**Stormwater Management/BMP Facilities
Record Drawing/Construction Certification
*Review Tracking Form***

County Plan No.: 5-30-97
 Project Name: STONEHOUSE SEC 4A Leather Leaf ~~Basin B~~
 Stormwater Management Facility: BASIN B DRY DET 9815 LEXINGTON LEX
 Phase: I II III

RECORD DRAWING
 OF
BASIN B
SECTION IVA
AT STONEHOUSE

Re: Stonehouse Section 4A Leather Leaf, Basin B
Dry Pond near 9815 Turning Leaf
County BMP ID Code: WC 038

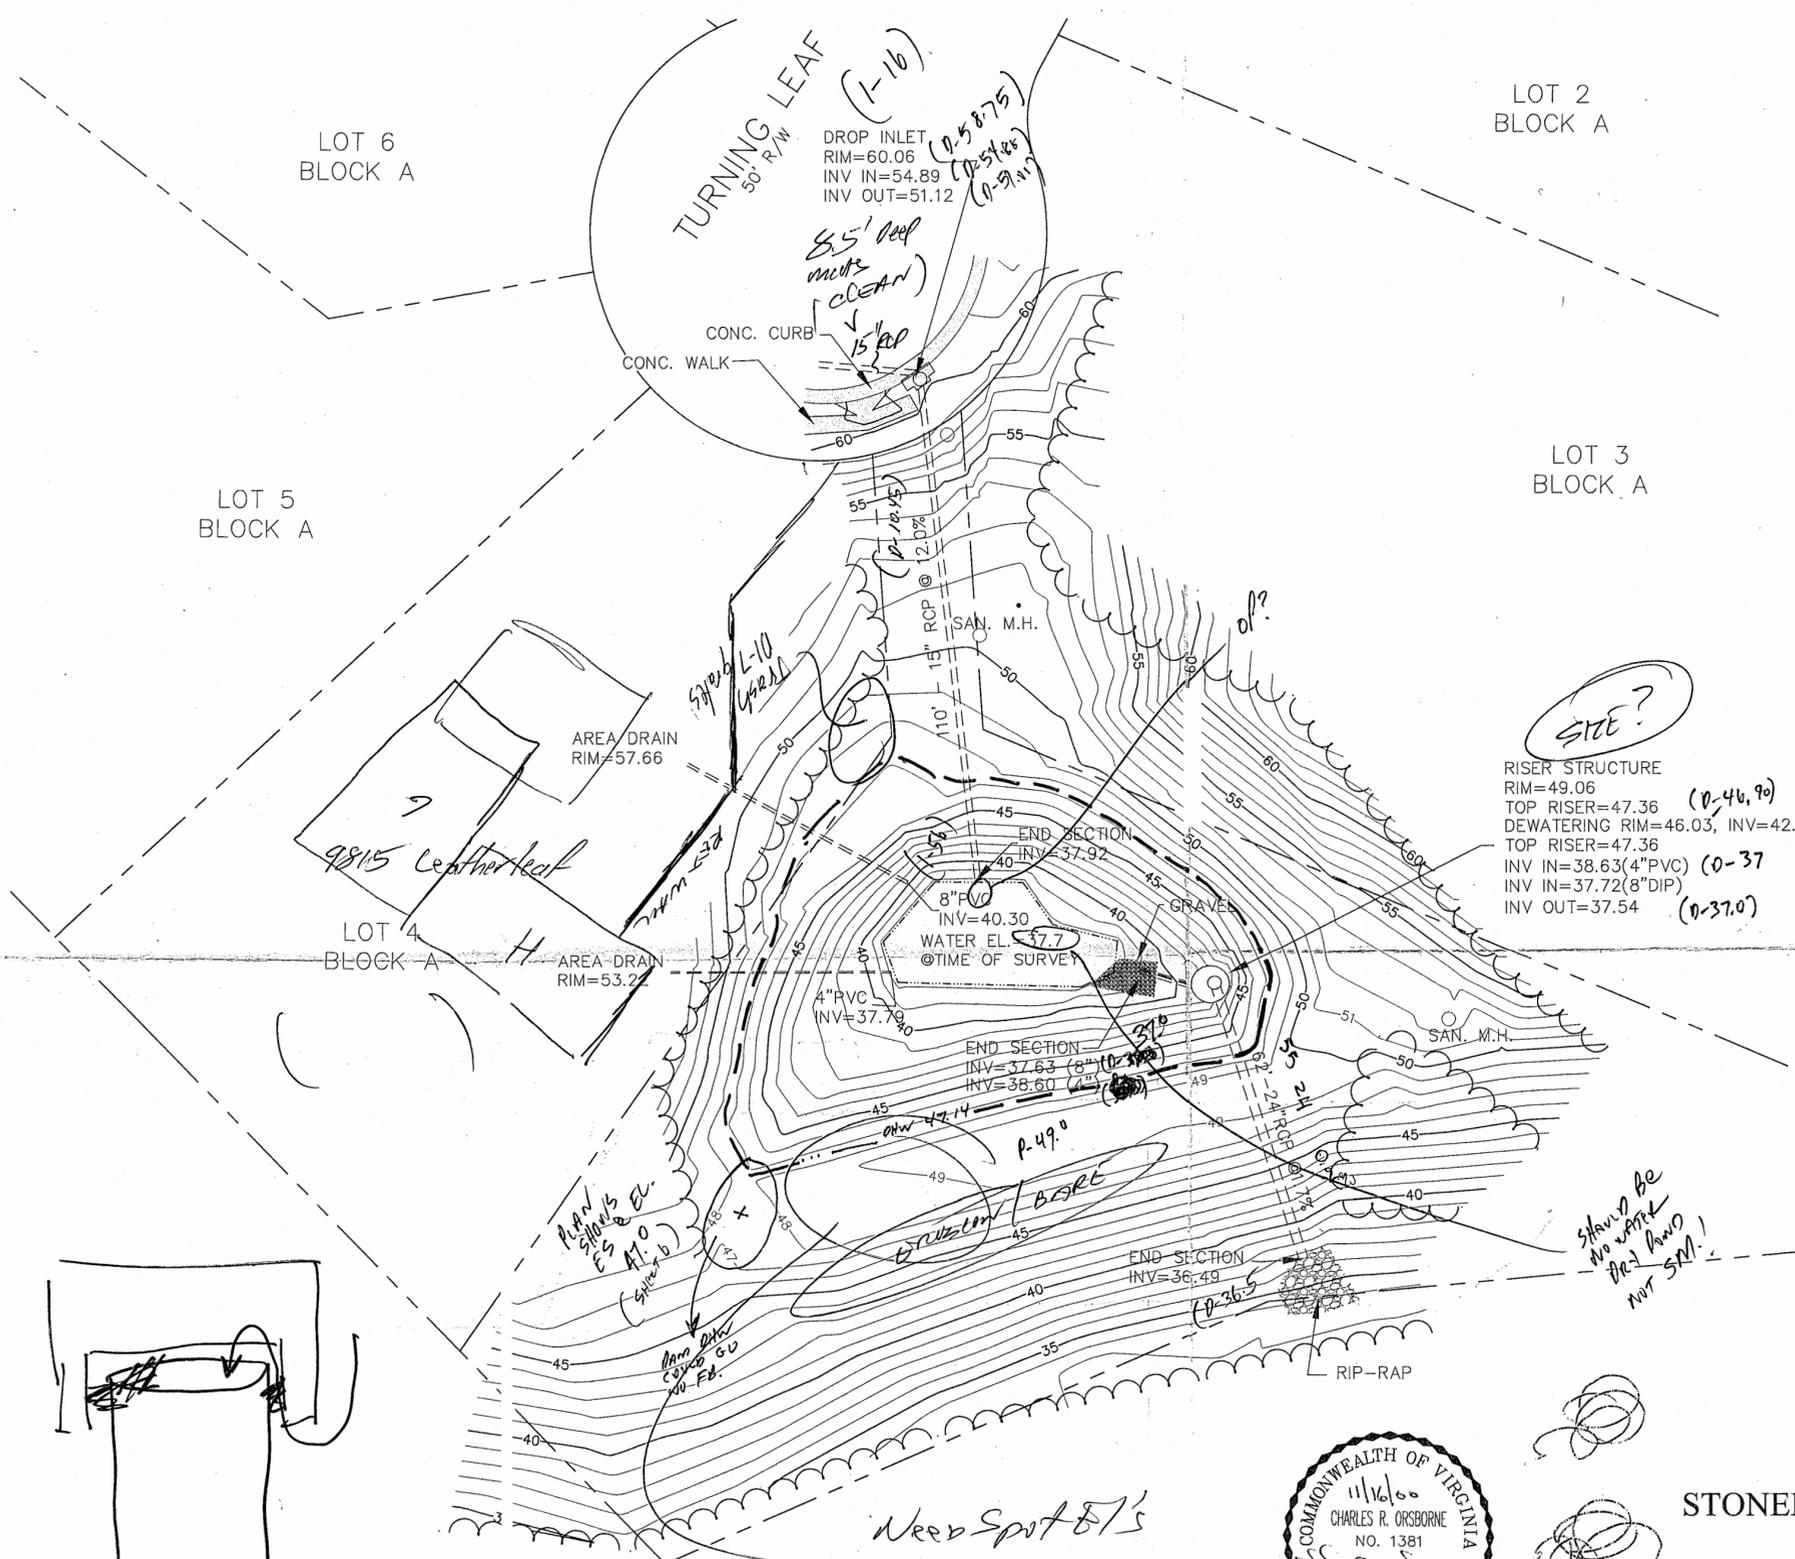
Show
 Plan view
 MR
 No Bench
 Present.
 Ave.?
 ES?

Need Spot E/Ls
 Contours
 not right
 TW=12' and 20'

RECORD DRAWING
OF
BASIN B
SECTION IVA
AT STONEHOUSE

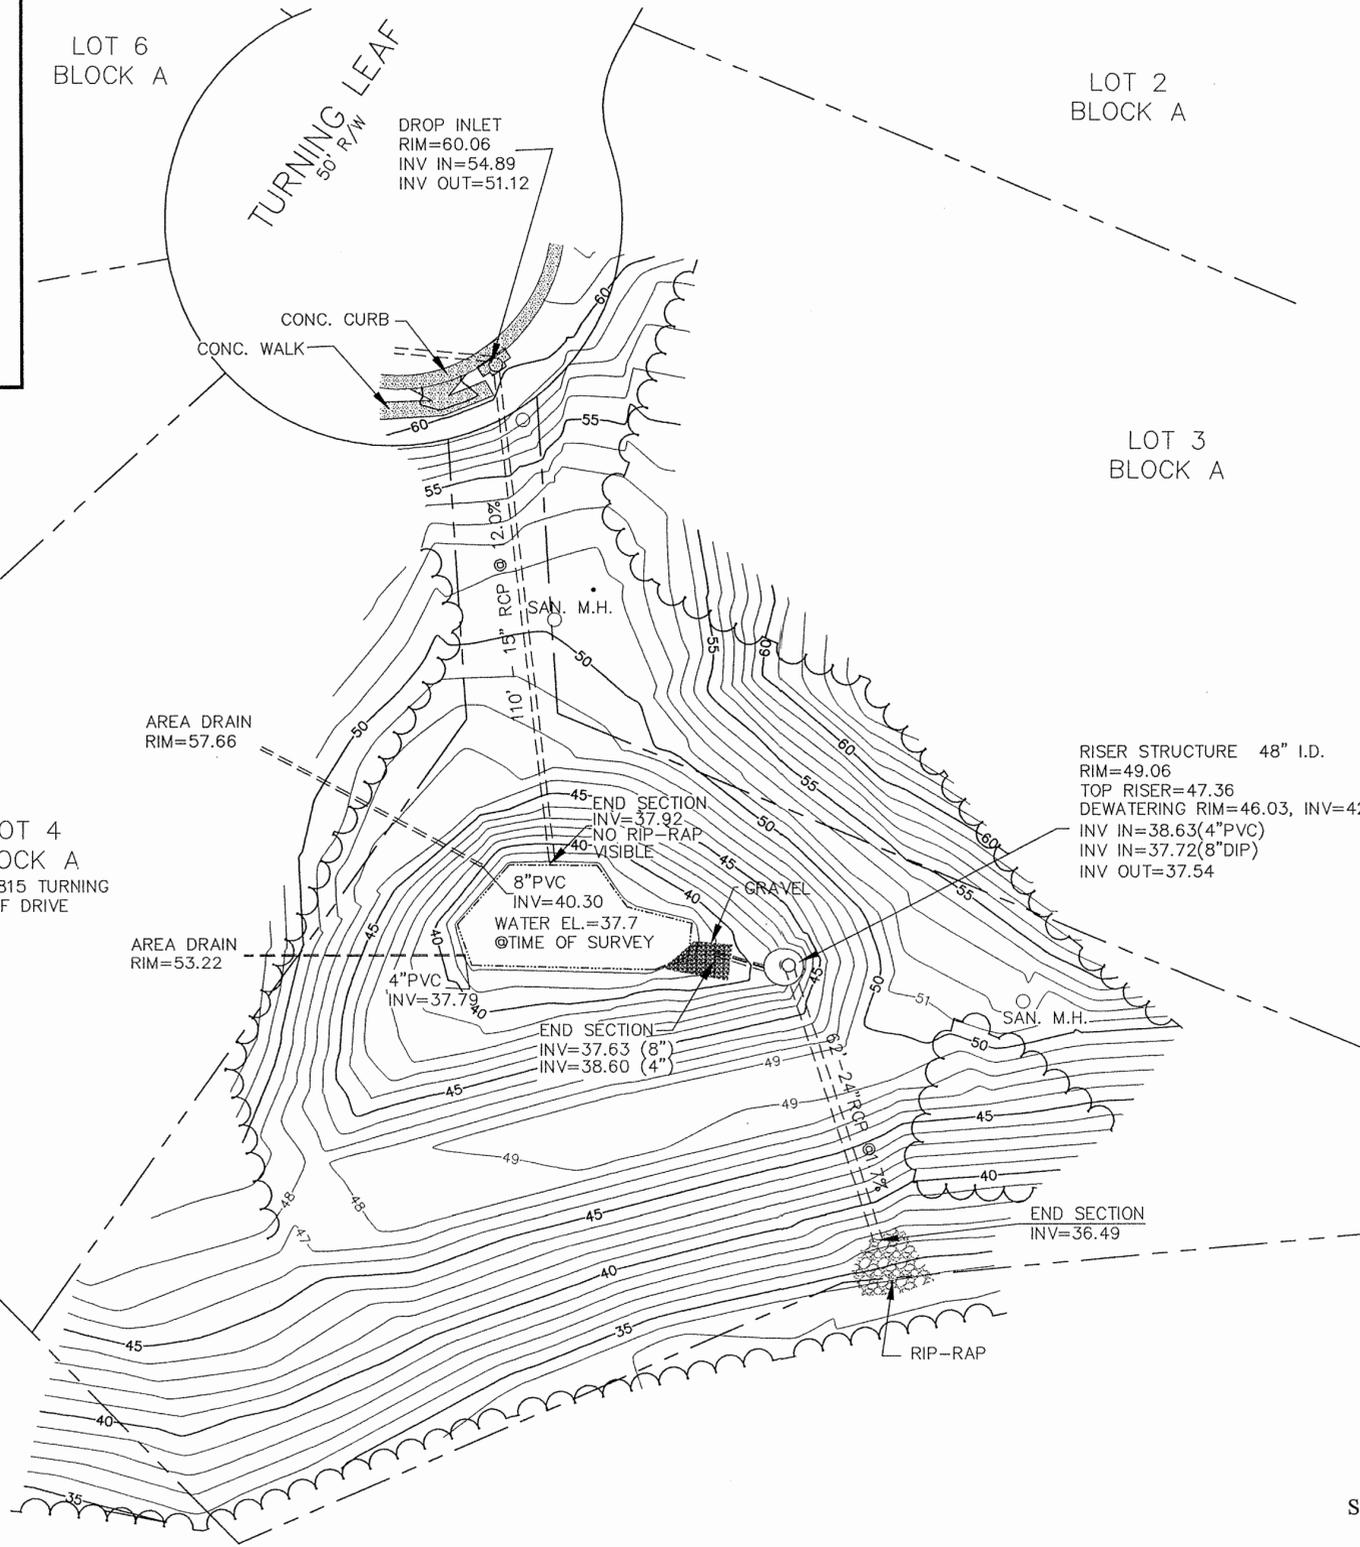
2. ~~Add the detention basin outlet structure detail as provided on Sheet 11 of the approved plan set to the as-built (record) drawing for the facility. This detail provides important information about the facility. Annotate the detail as necessary with field-obtained construction information.~~

Show the following additional information on the record drawing: size of riser; size of the higher level (dewatering) orifice; crest elevation/dimensions for the emergency spillway; outlet protection at the end of the 15-inch storm drain which inflows to the basin (ie. Structure 1-56); and show the street address on Lot 4 as 9815 Turning Leaf.

If possible, add the following County identifiers to the lower right hand corner of the record drawing: County Plan No. S-30-97 and BMP ID No. WC 038.

REVISED PER COUNTY COMMENTS: 2/25/03

2-27-03
OK ✓

2-27-03
OK ✓

SEDIMENT AND ATTENUATION BASIN - SECTION A-A (BASIN B)

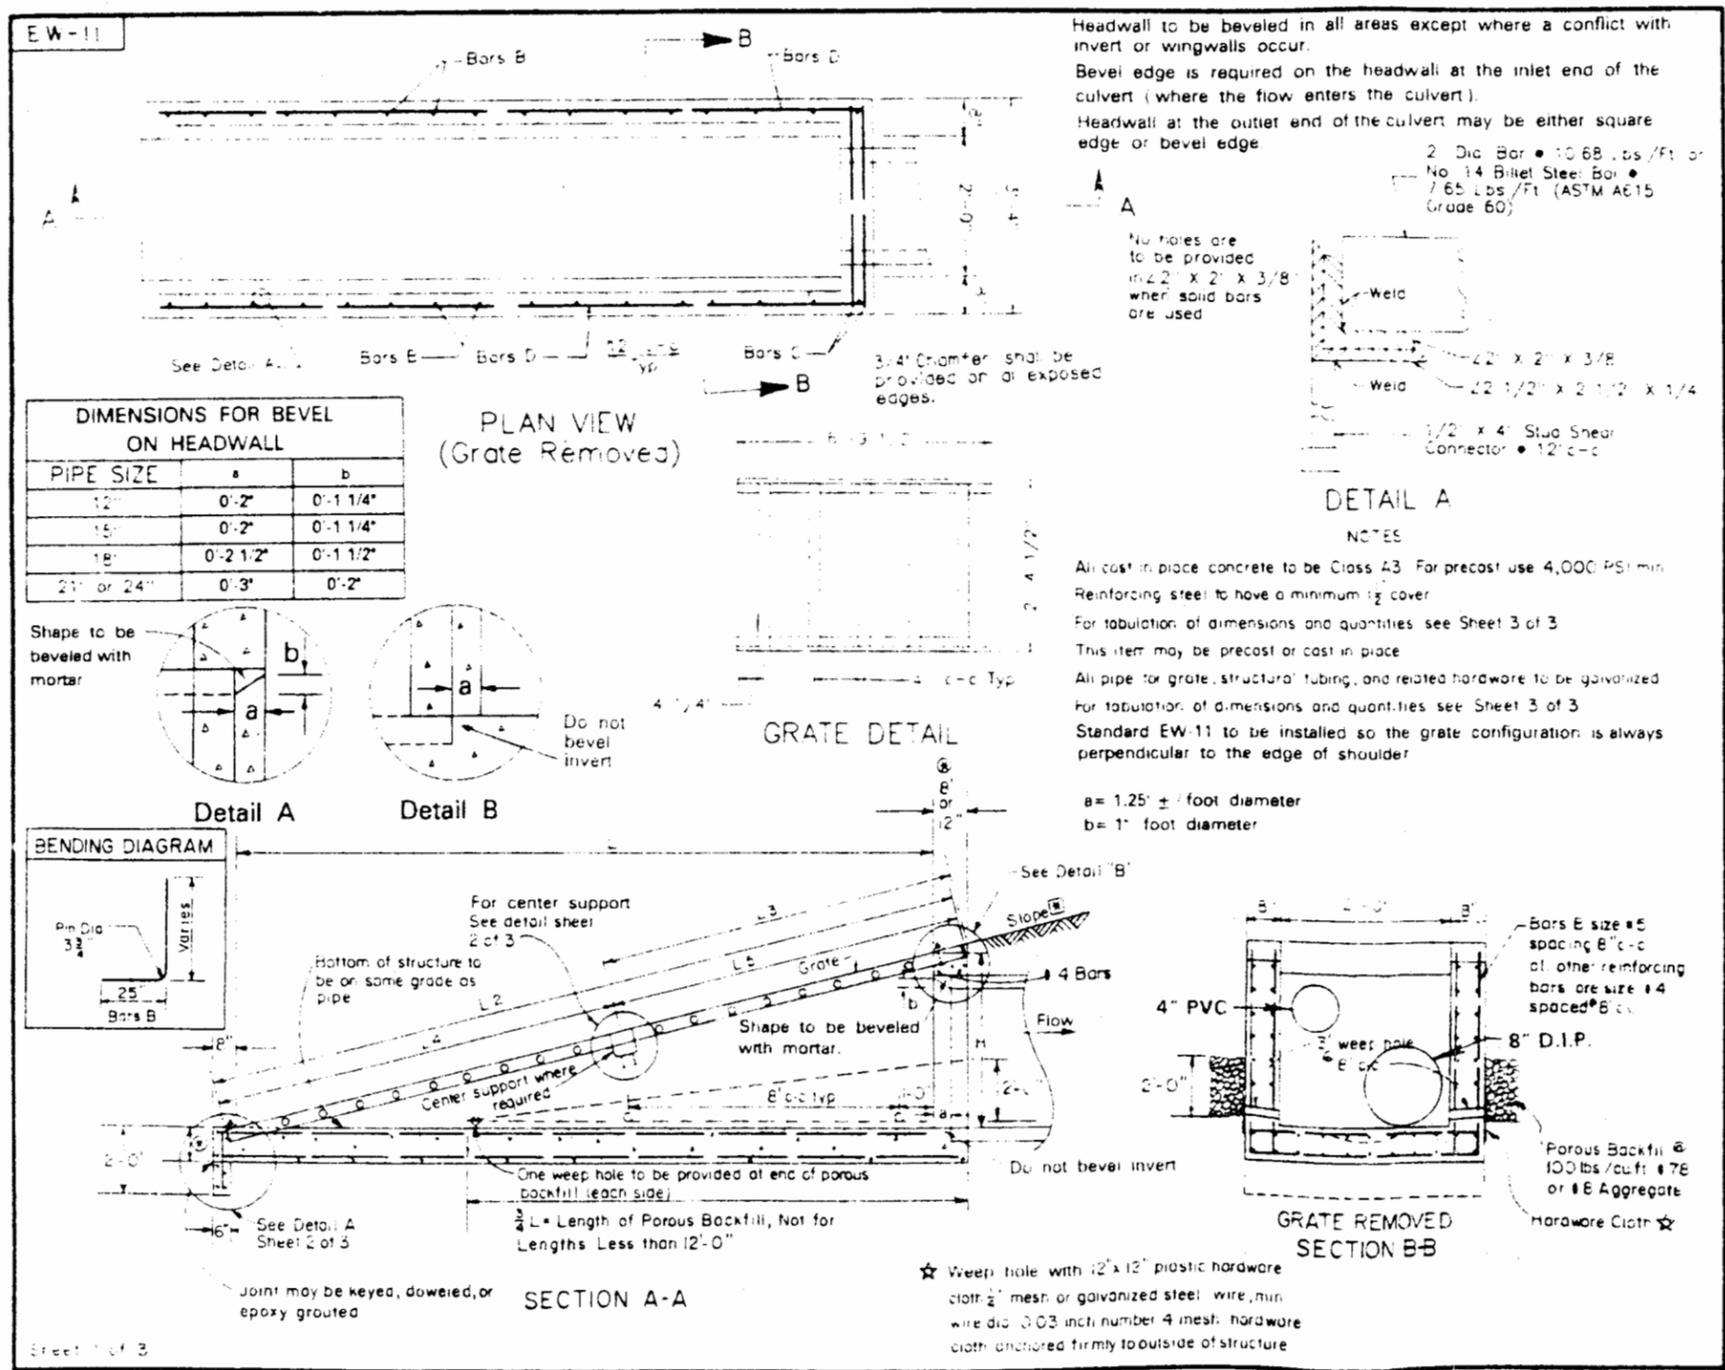
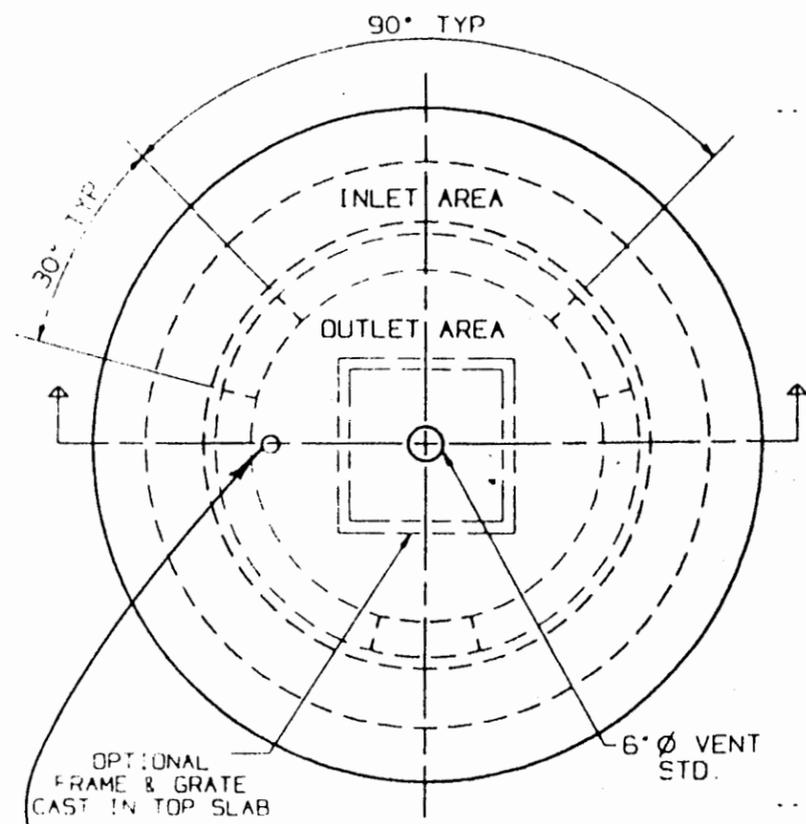
10. ✓ 4-14-03 Remove the perforated corrugated polyethylene pipe which served as a dewatering tube during construction (ie. temporary sediment basin mode). The final configuration of the higher level orifice must meet the requirements of Sheet 12 of the approved design plan. The final configuration for the orifice called for a 6-inch opening with a 6"x 6" ductile iron turn-down tee fitting.

Lot Elevation from Bottom of Pit = ~ 30'

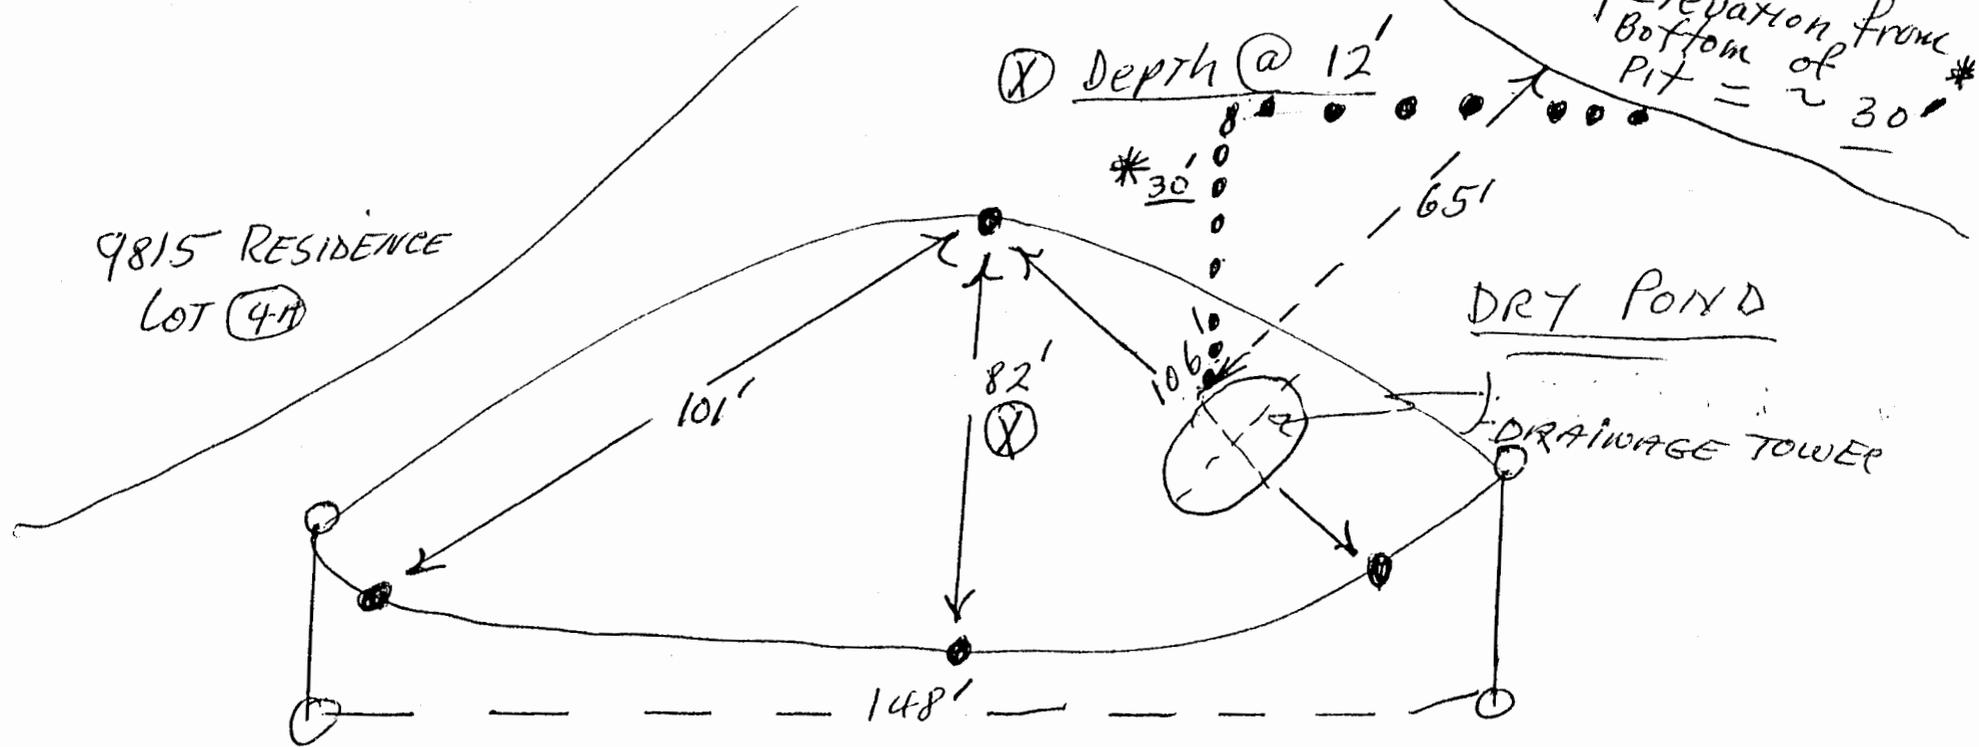
1. The overall rough dimensions of this pond are attached but basically it is 12' depth by 148' long and in areas it is over 100' wide. The edge of Lot 3A to the maximum depth of the pond is about 65', and the elevation from the lot property line to the depth is about 30'. (Drawing attached)
